22 June 2025

**PROPOSED DEVELOPMENT ON ERVEN 1469, 1470, 1471, 1473 & 1479, KLEINBAAI:  
CAPACITY ANALYSIS OF THE BULK WATER AND SEWER SERVICES**

DETAIL 1

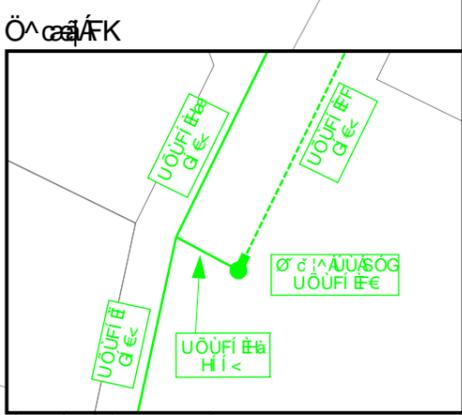
The master plan indicated that the proposed development should be accommodated in the existing Kleinbaai reservoir distribution zone. The connection to the existing system should be done on the existing 160 mm diameter pipeline in Bosbok Street, as shown in Figure 1 attached.

It is therefore proposed that link services item OGW3.3 is constructed along the entire eastern and northern boundary of the proposed development to form the first section of the proposed “ring main” for Kleinbaai:

The route of the proposed pipeline is schematically shown on Figures 1 & 2, but has to be finalised subsequent to a detailed pipeline route investigation.

It is, however, recommended that the first section of the proposed “ring main” (link services item OGW3.3; refer to section 1.3.1) is constructed along the entire eastern and northern boundary of the proposed development.
